**PRELIMINARY DECISION
Jemena distribution
determination
2016 to 2020**

**Attachment 6 – Capital
expenditure**

October 2015

AUSTRALIAN
ENERGY
REGULATOR

Figure 6.1   Jemena's total actual and forecast capex 2011–2020

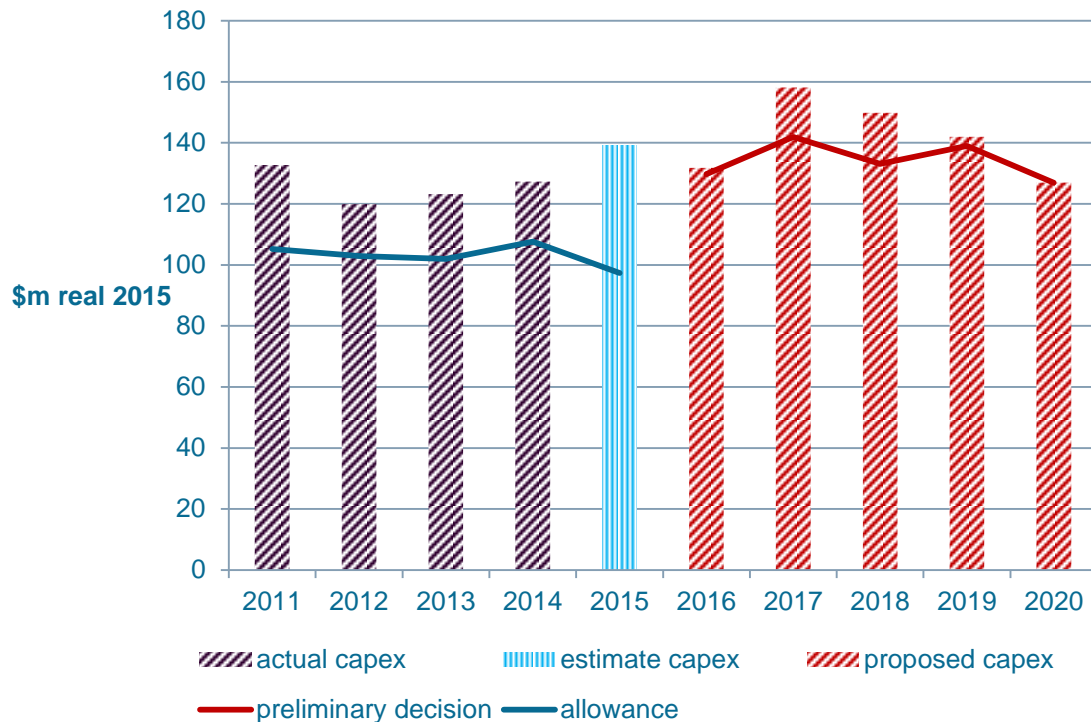
Figure 6.1 shows the increase between Jemena's proposal for the 2016–20 regulatory period and the actual capex that it spent during 2011–15. Jemena has stated that this forecast increase in capex is mainly attributable to a need to:[5]

Figure 6.4   Capex per customer (000s, $2013–14), against customer density

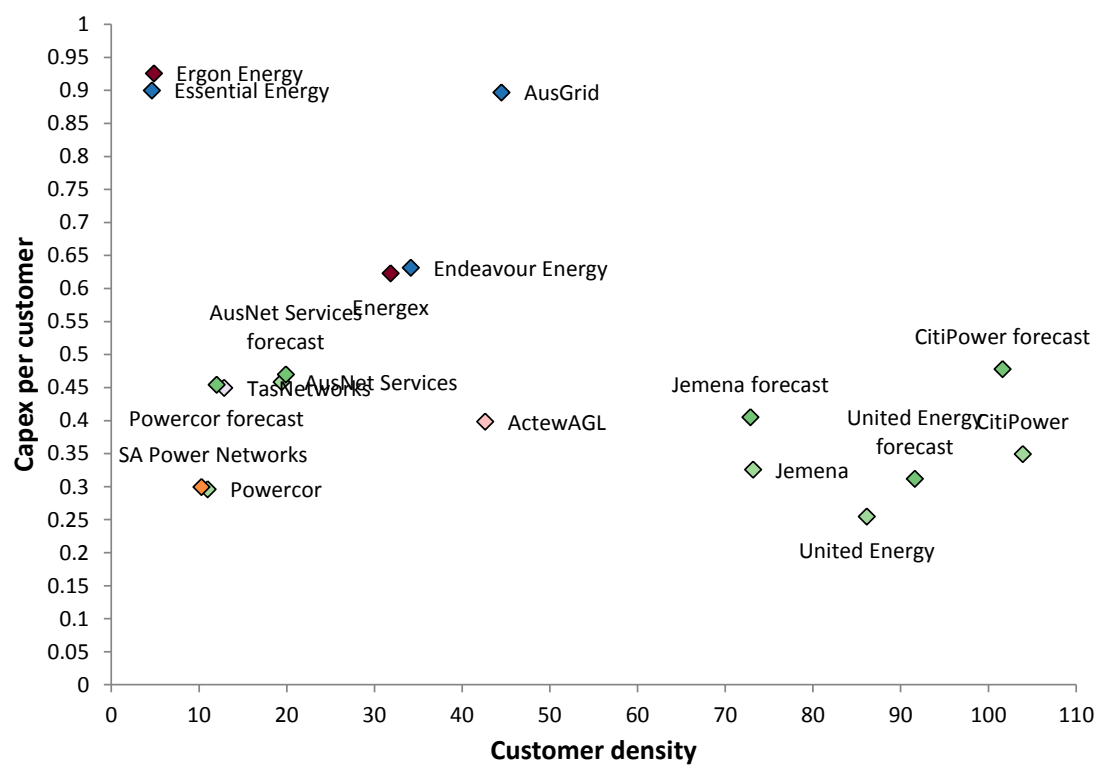
Figure 6.4 shows that Jemena performed well in the 2008–12 period in terms of capex per customer. However, Jemena's capex per customer will increase for the 2016–20 period based on its proposed forecast capex.

Figure 6.5 Capex per maximum demand (000s, $2013–14), against customer density

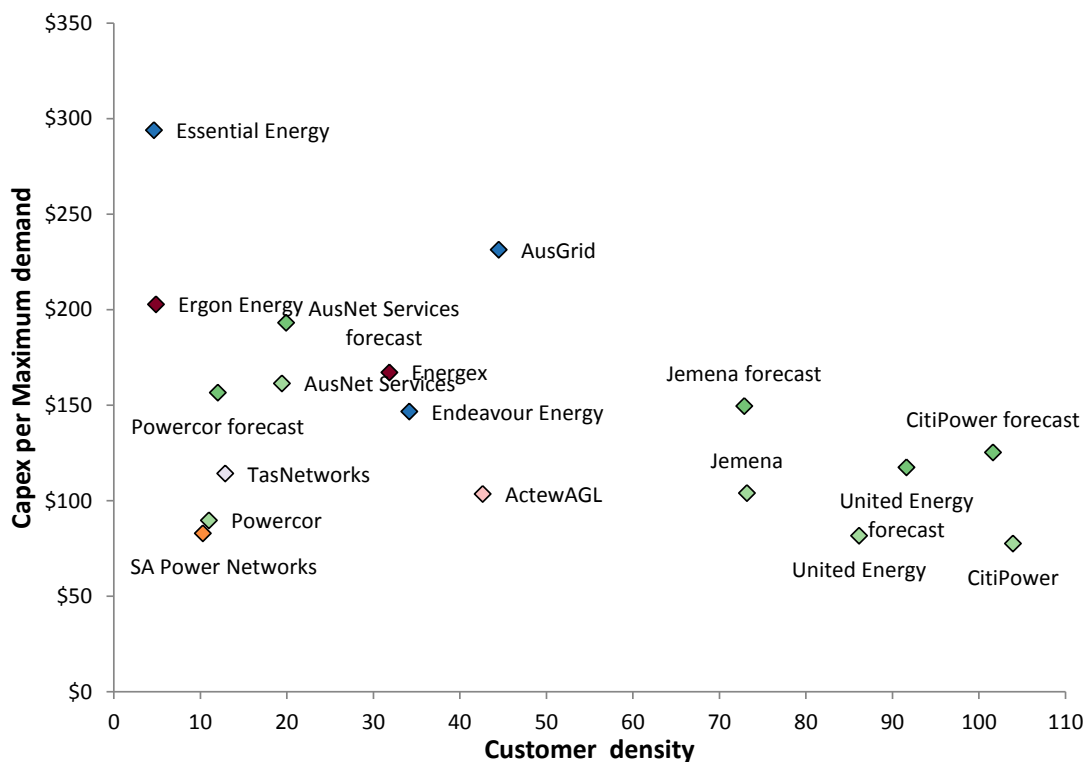
Figure 6.5 shows that Jemena performed well in 2008–12 in terms of capex per maximum demand. Again capex per maximum demand is forecast to increase for Jemena in the next period.

Figure 6.6 Jemena total capex – historical and forecast for 2001–2020

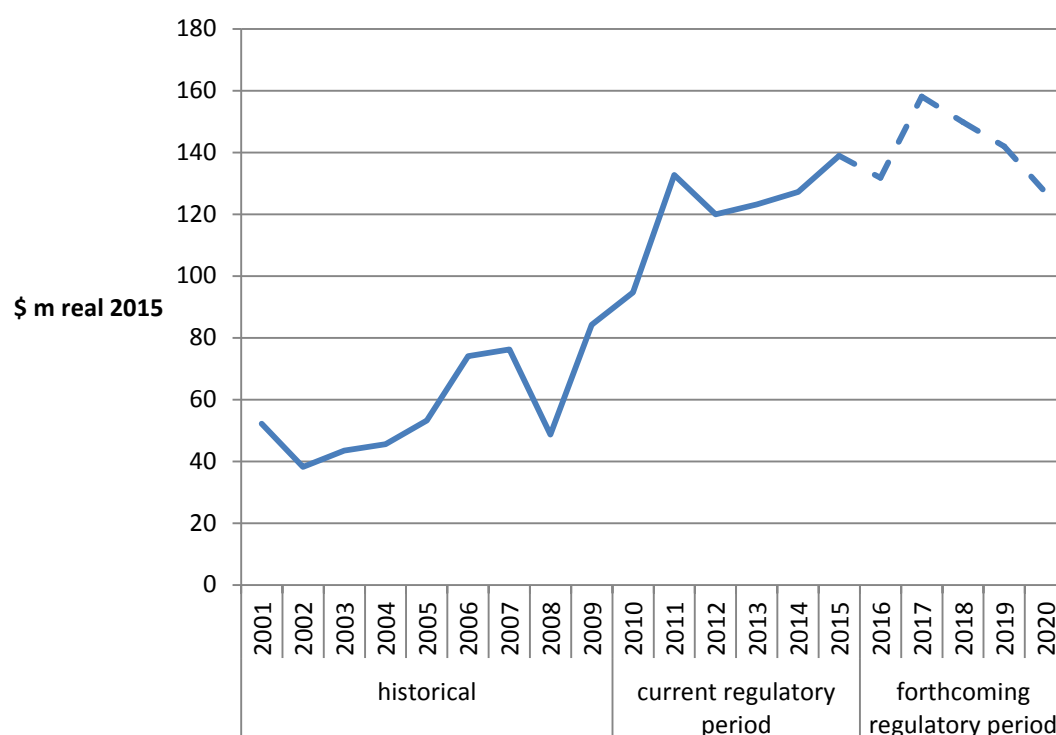
Figure 6.6 shows actual historic capex and proposed capex between 2001 and 2020. This figure shows that Jemena's forecast is significantly higher than historical levels (actual spend), particularly for the first 3 years of the regulatory control period. We note that Jemena's capex falls towards the end of the regulatory control period.

Figure 6.7 Jemena's demand-driven augex historic actual and proposed for 2016–20 period ($2015, million, excluding overheads and one-off projects)

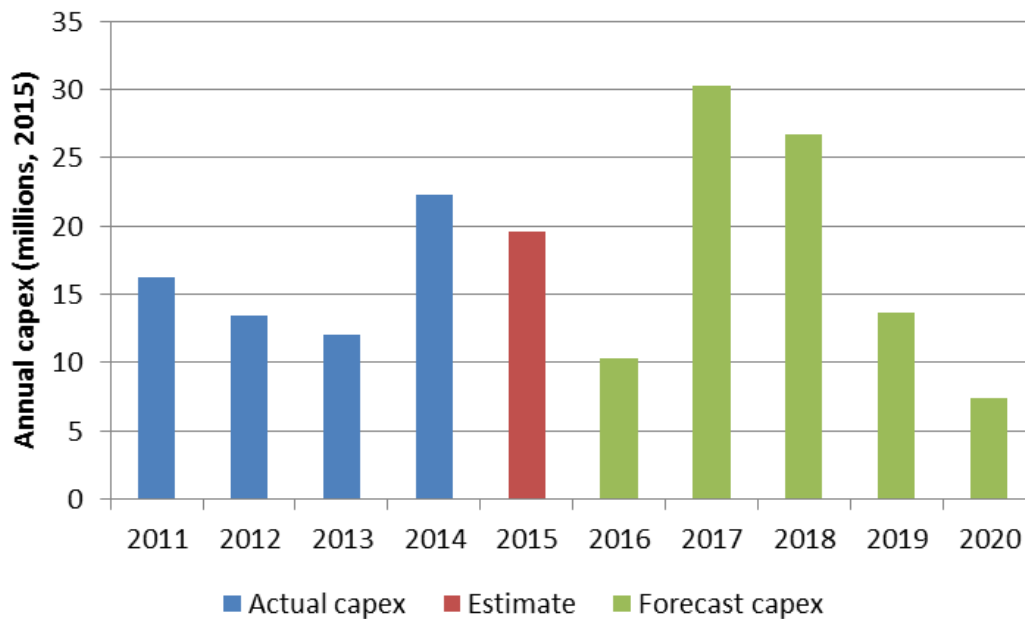
The largest component of Jemena's augex forecast is $88.4 million ($2015) for demand-related augex (excluding overheads). Figure 6.7shows that Jemena's demand-driven augex is 5.6 per cent higher than its actual demand-driven augex in the 2011–15 regulatory control period.[68]

Figure 6.8   Jemena zone substation utilisation 2010 and 2014 actual, and 2020 forecast

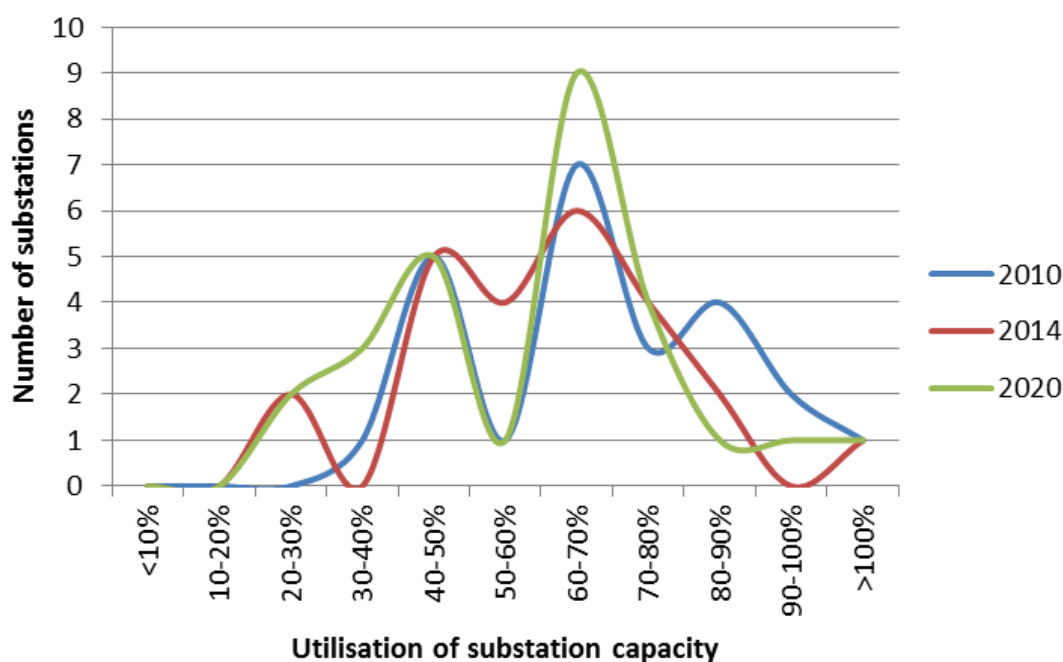
Figure 6.8 shows Jemena's zone substation utilisation between 2010 and 2014, and forecast utilisation in 2020 (at the end of the regulatory period). Between 2010 and 2014 Jemena undertook network augmentation, which is shown in a significant decrease in the number of substations operating above 80 per cent of their maximum capacity. The flattening of maximum demand between 2010 and 2014 also contributed to reduction in the utilisation of the network. As of 2014, there is only one substation operating above its maximum capacity (Sunbury).

Figure 6.10 Jemena 2011-15 regulatory control period connections capex actual and allowed ($2015/16, million)

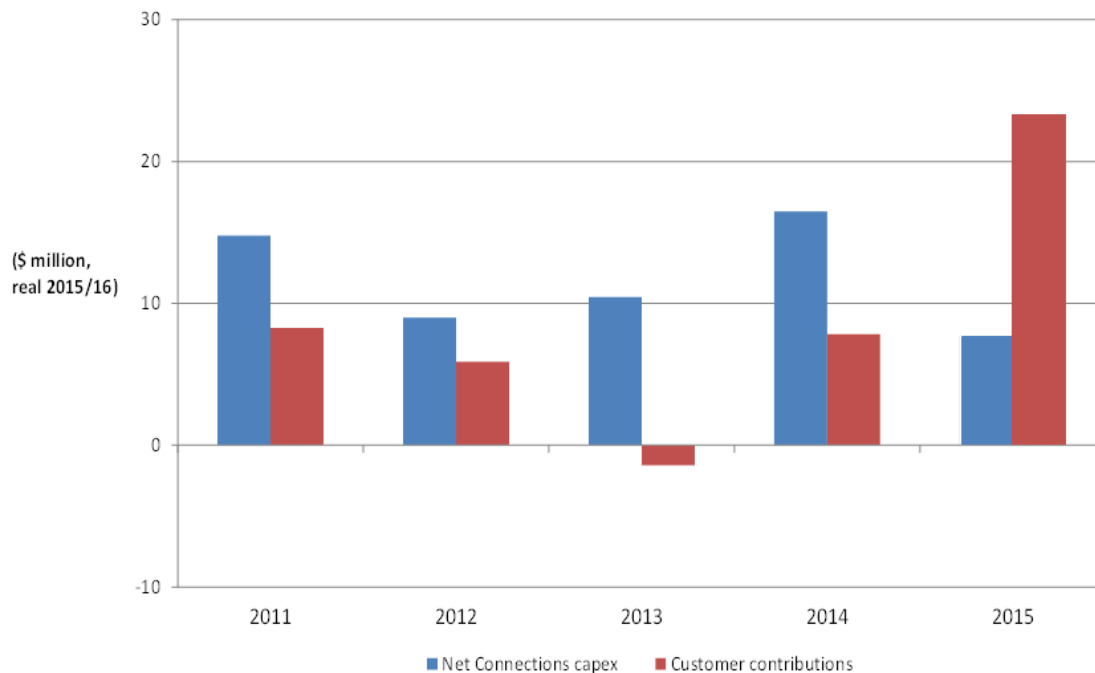
Figure 6.10 shows that compared with its allowance in the 2011-15 period, Jemena overspent on net connections capex and received less customer contributions than forecast (with the exception of 2013). We note that a major feature of the regulatory framework is the incentives Jemena has to achieve efficiency gains whereby actual expenditure is lower than the allowance. Differences between actual and allowed connections capex could be the result of efficiency gains, forecasting errors or some combination of the two.

Figure 6.11   ACIL Allen Jemena residential connection growth and HIA Victorian dwelling growth – actual and forecast

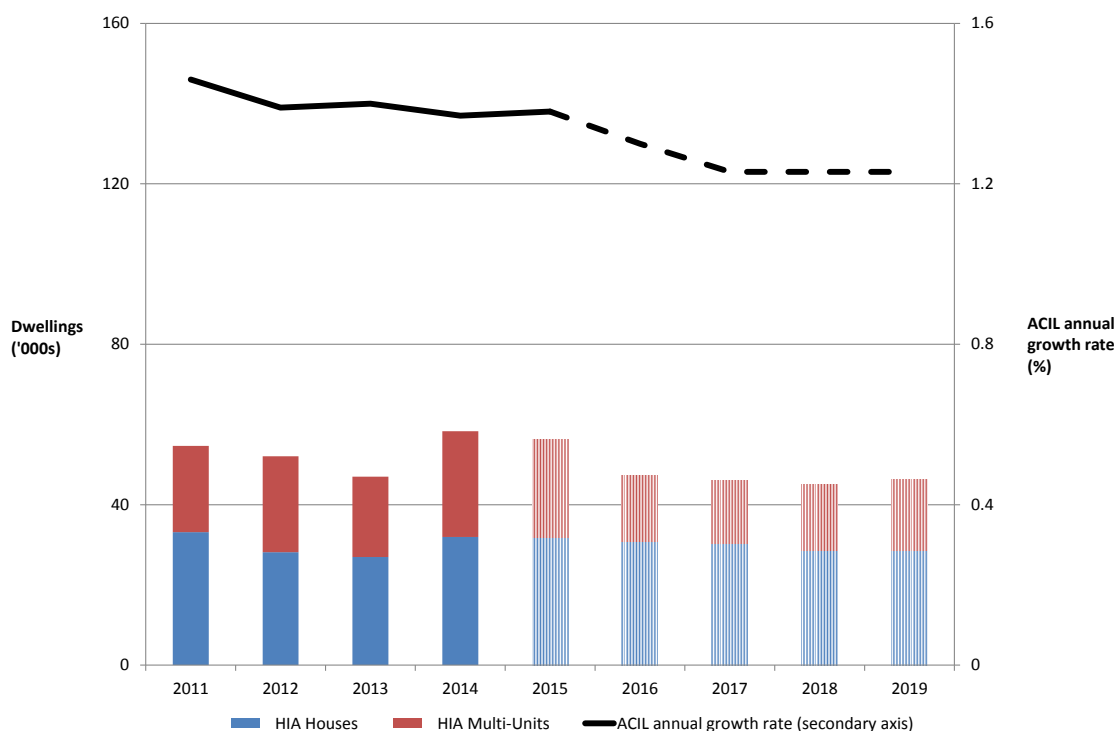
We note the forecast growth of both series follow the same rates of initial decline in growth before plateauing later in the forecast period. On this basis, we are satisfied that the volume growth rates relied on by Jemena for residential connections represent an unbiased forecast.

Figure 6.14   Jemena- Actual and forecast repex ($ million, 2015)

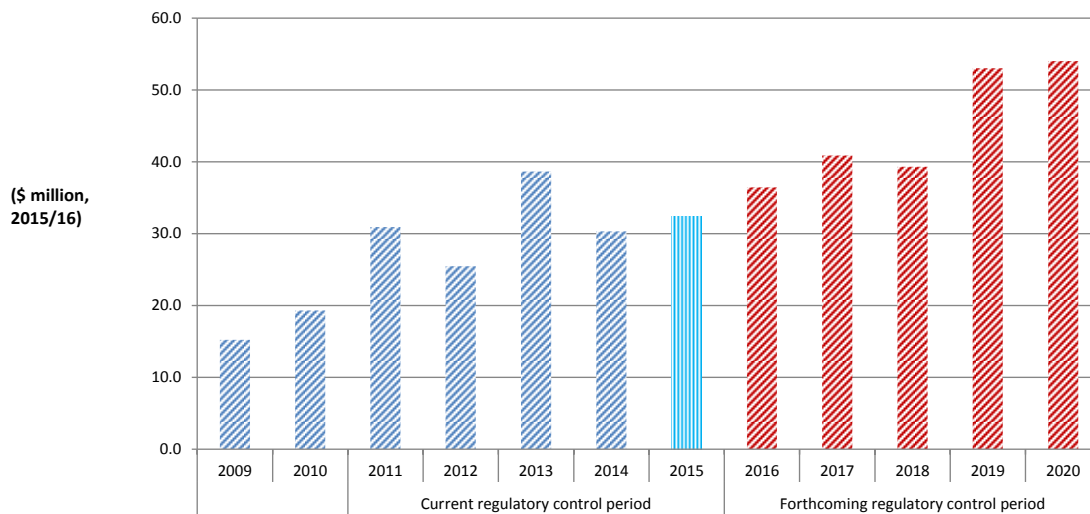
Figure 6.14 shows Jemena's repex spend has been variable across time, and is forecast to increase above historical levels for the 2016–20 regulatory control period. .

Figure 6.15 Relationship between system wide SAIFI and non-excluded interruptions caused by asset failures

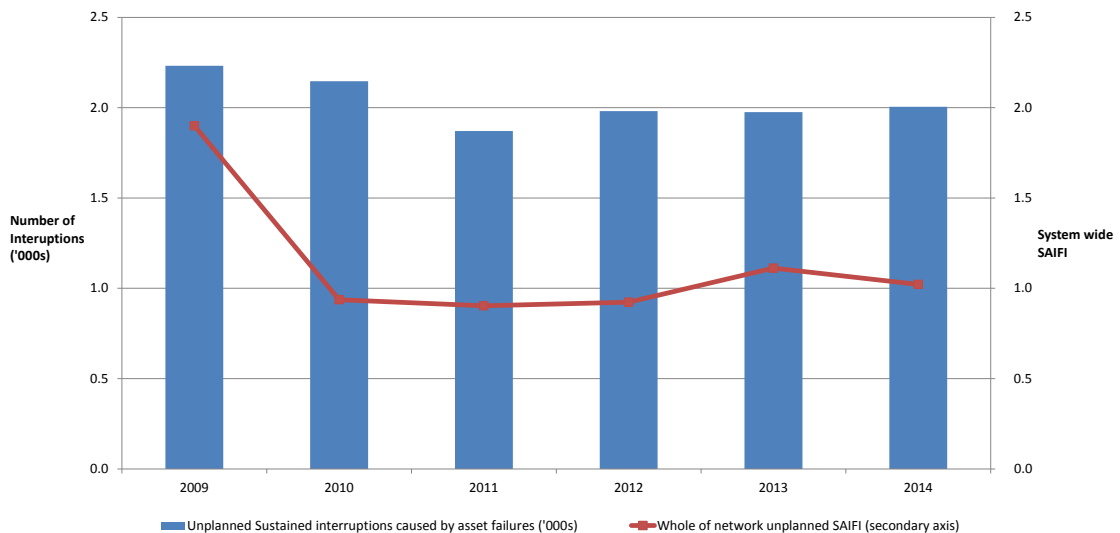
Figure 6.15 shows Jemena' both outages due to asset failures and SAIFI have generally been flat across time, with the exception of a significant decrease in SAIFI in 2010. The overall stability in both of these measures indicates that the replacement practices from the last period have been sufficient to meet the capex objectives.

Figure 6.16   Jemena estimated residual service life network assets

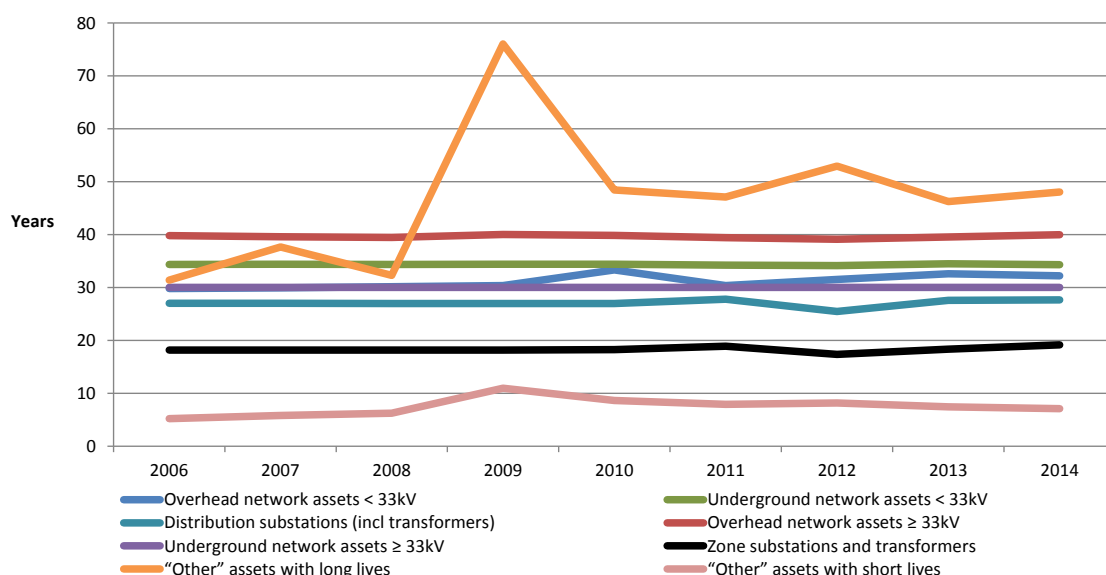
Figure 6.16 shows that Jemena' residual asset lives have generally been flat over the period 2006-2014. This means that, on average, Jemena' network assets are staying the same age.

Figure 6.18 Jemena's non-network capex by category ($million, 2015)

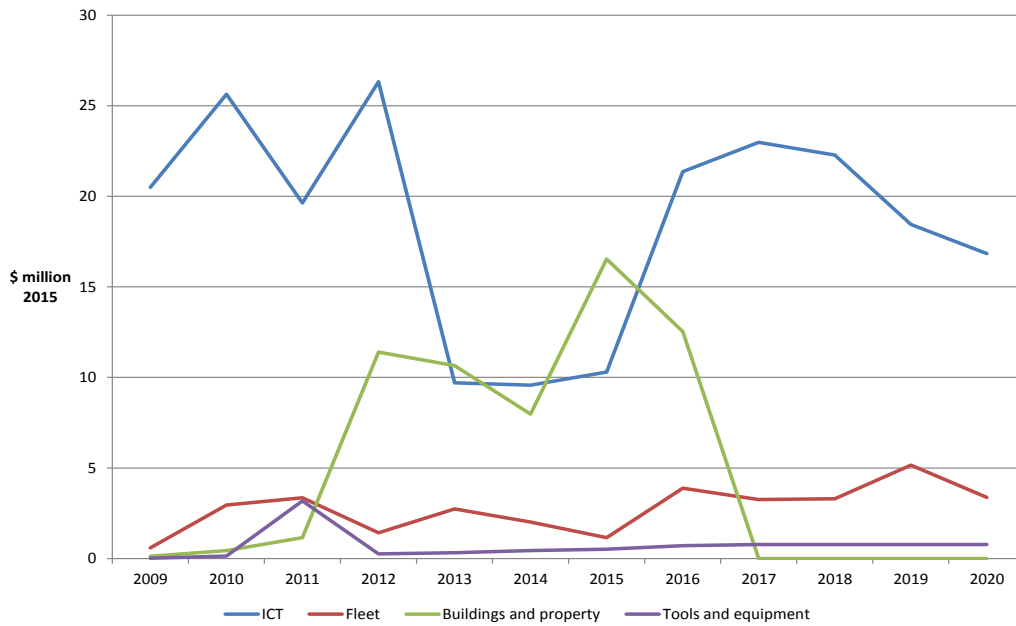
Figure 6.18 shows a trough in ICT capex in the period from 2013–2015, followed by a significant increase in forecast capex in the 2016 year. This pattern reflects the front loading of expenditure in the 2011–15 regulatory control period, with 61 per cent of ICT

Our analysis suggests that the high level of capex in the 2016 year relative to other years of the forecast period shown in Figure 6.18 is in fact caused by buildings and property expenditure of $12.5 million in that year. Buildings and property capex falls to zero for all subsequent years of the 2016–20 regulatory control period. We therefore sought further information from Jemena in relation to its forecast buildings and property capex to confirm the need and timing of the forecast capex for this category.

Figure 6.19   Comparison of peak demand forecasts of Jemena and AEMO (MW, non-coincident, summated connection point forecasts)

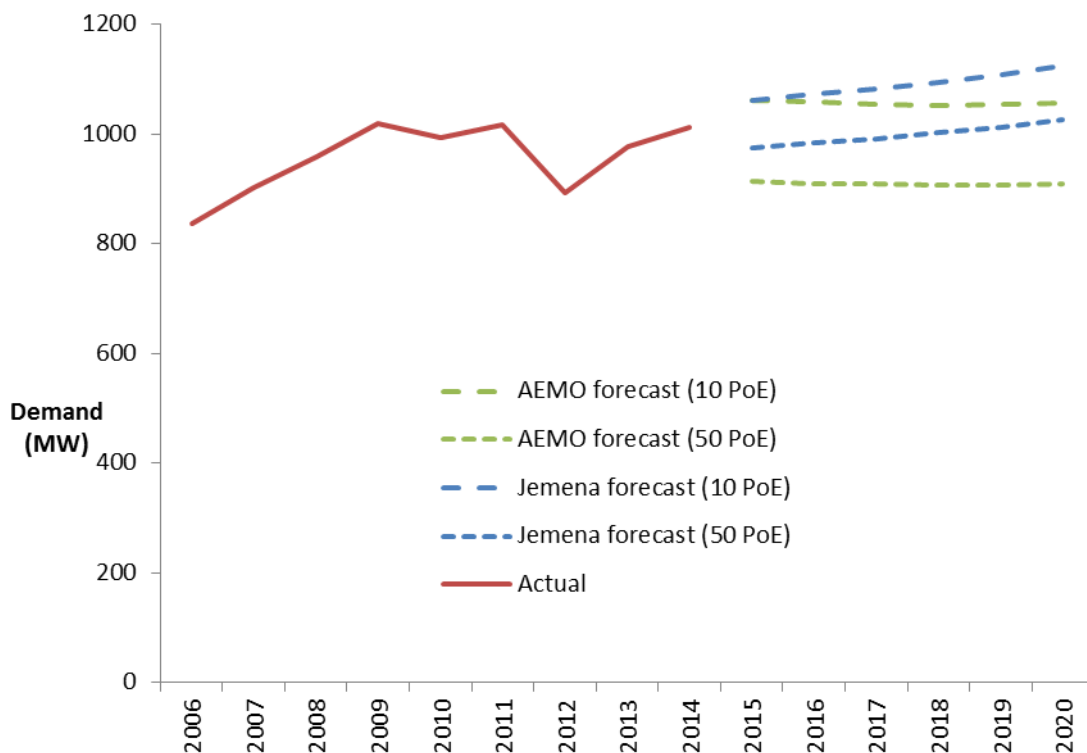
As shown further in Figure 6.19, Jemena's demand forecasts for the 2015–20 period are slightly higher than the actual demand observed for its network during 2006–14. Jemena forecasts continued demand growth on the network. This contrasts with AEMO's Connection Point Forecasts, published in September 2014, which forecasts little or no growth in connection point demand on Jemena's network for the same period.[212]

Jemena forecasts moderate demand growth for 2015–20, whereas other independent forecasts from AEMO predict low or no growth over this period. While actual connection point demand increased on Jemena's network in 2013 and 2014 (see Figure 6.21), the observed changes in demand patterns within the span of nine years raises the question of whether the recent flattening of demand is an aberration (and demand will return to growth) or a realistic expectation of demand over the 2016–20 period.
